### **ADDENDUM NO. 2**

## **Hopewell Phase I East Infrastructure – Re-Bid**

**Issued From:** The City of Bloomington

**Issue Date:** April 28, 2023 **Letting Date:** May 3, 2023

PROJECT NO.: 03/15/2023 21-0049 MER MDW **RE-BID** LANDSCAPE SCHEDULE AND **DETAILS**

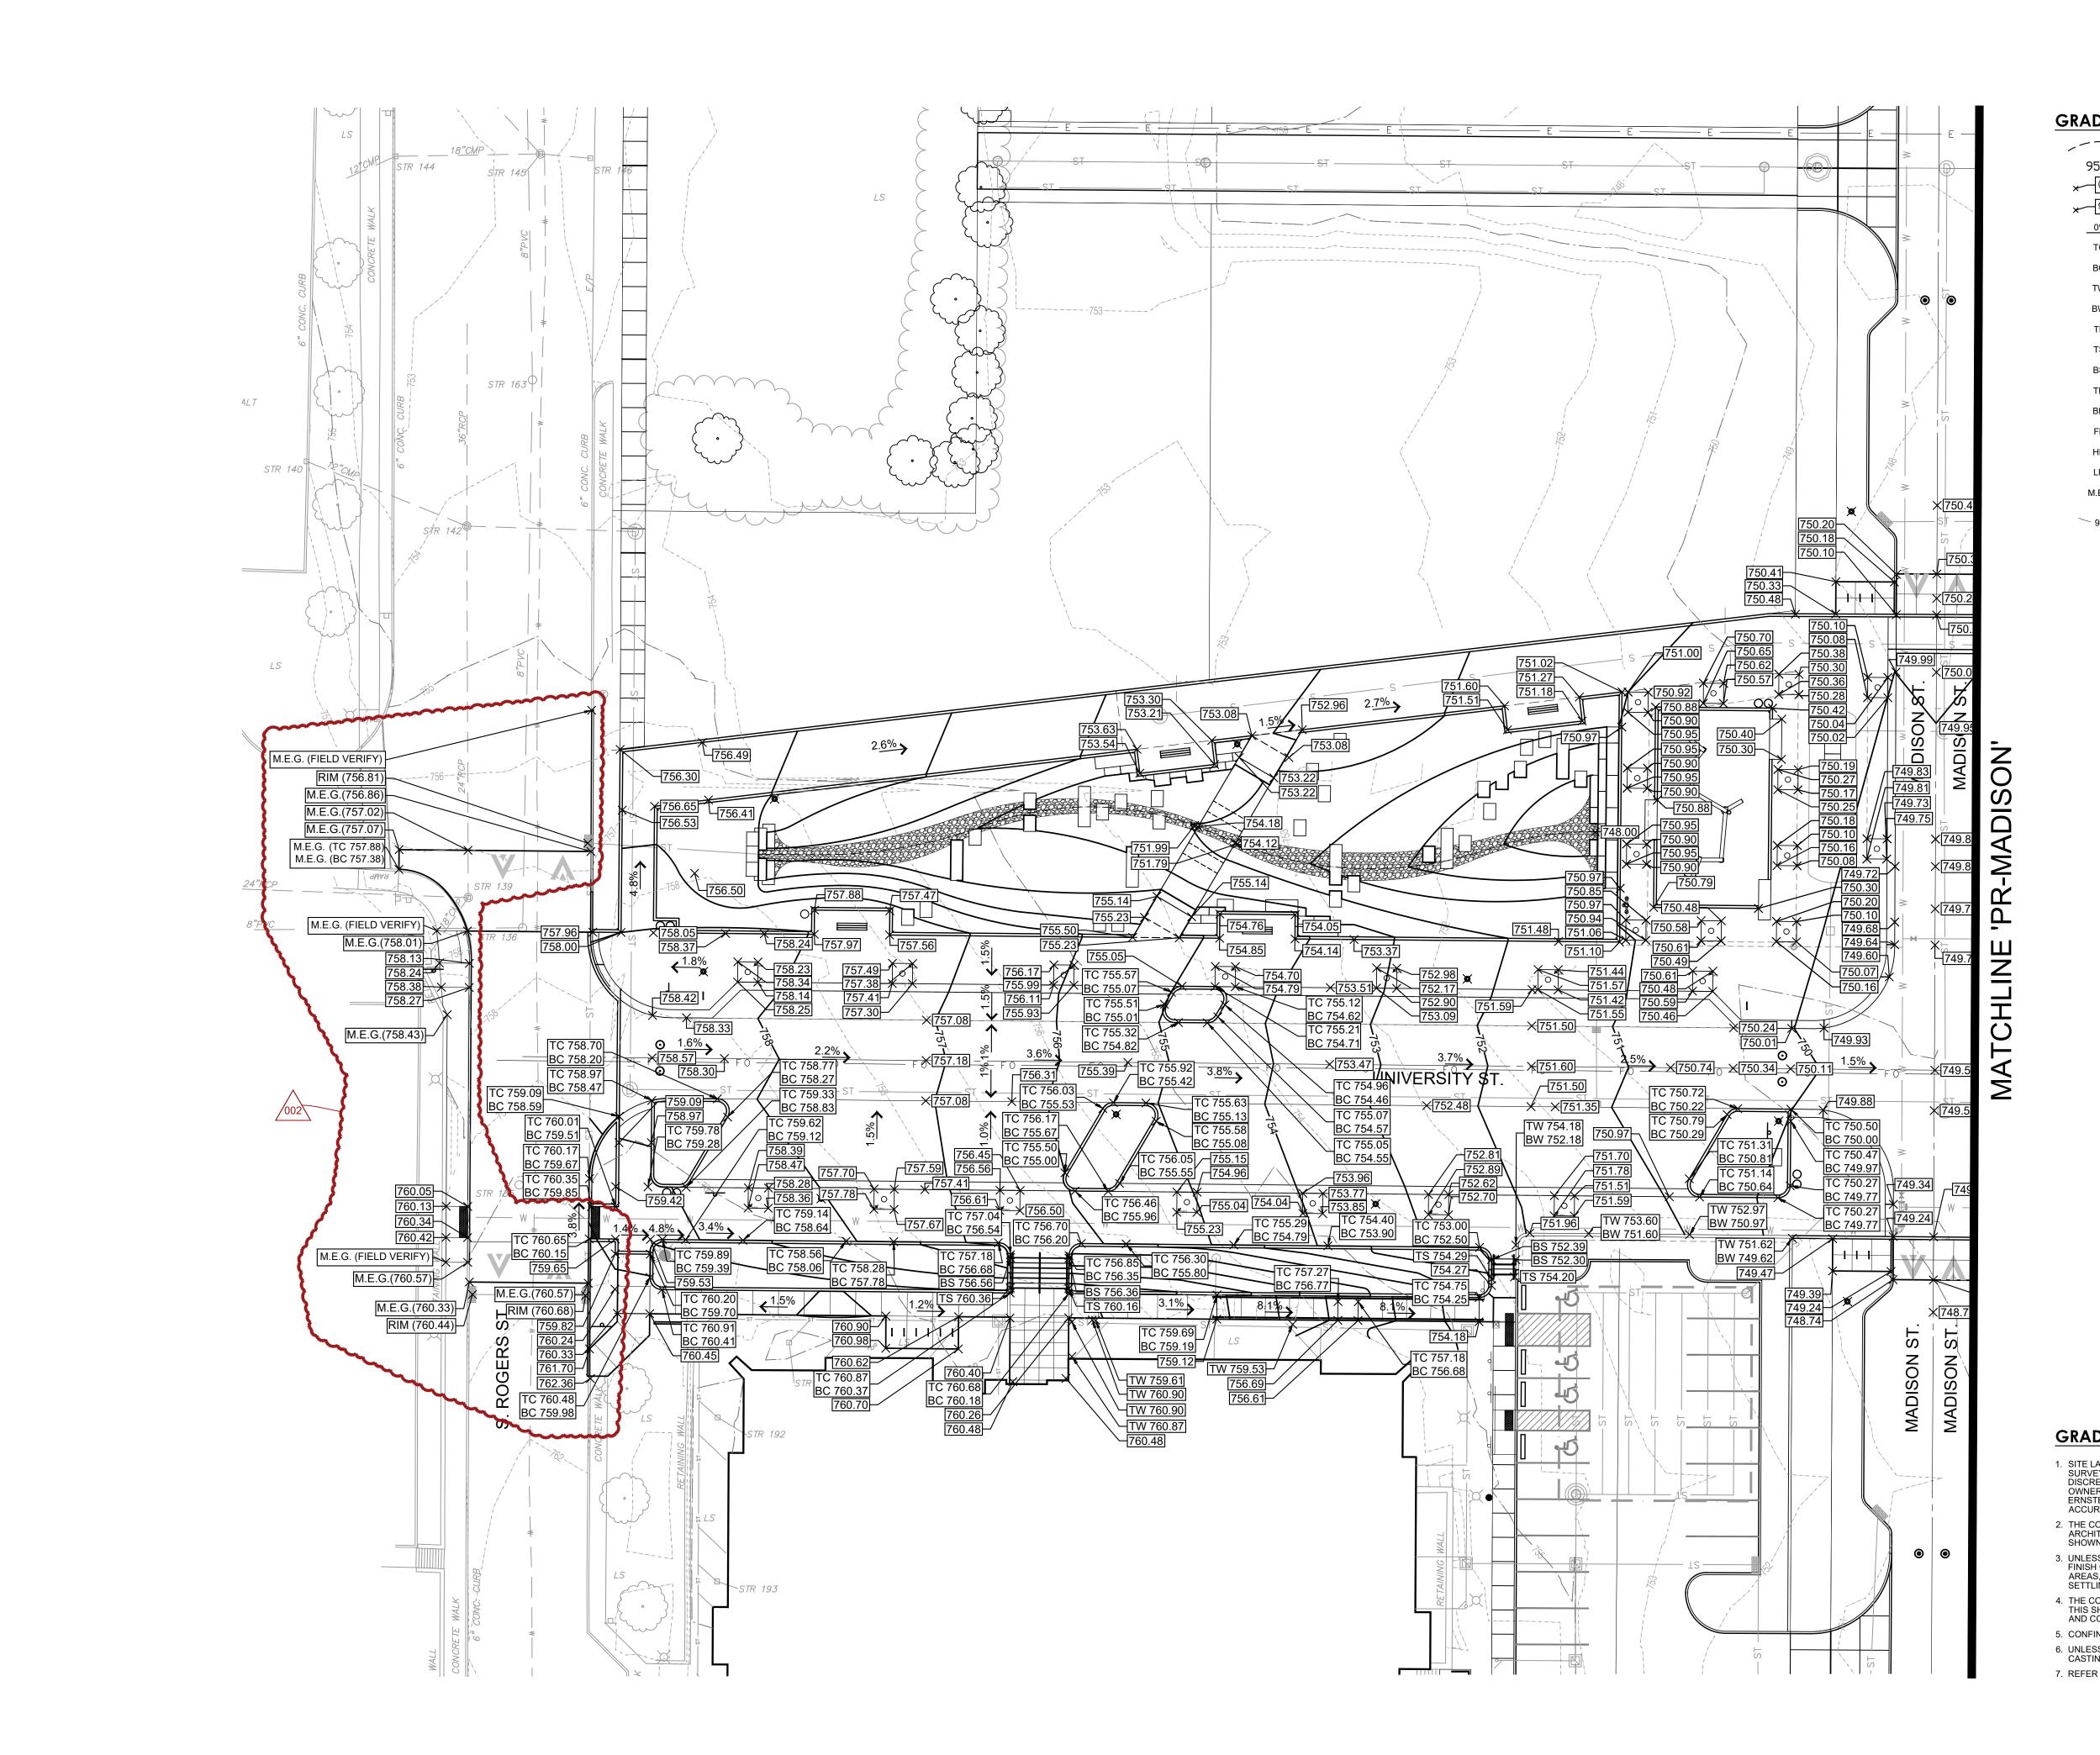
Drawing: L201 – Landscape Schedule and Details

**<u>DELETE</u>** existing sheet L201 – Landscape Schedule and Details in its entirety and **<u>INSERT</u>** attached revised sheet L201 – Landscape Schedule and Details.
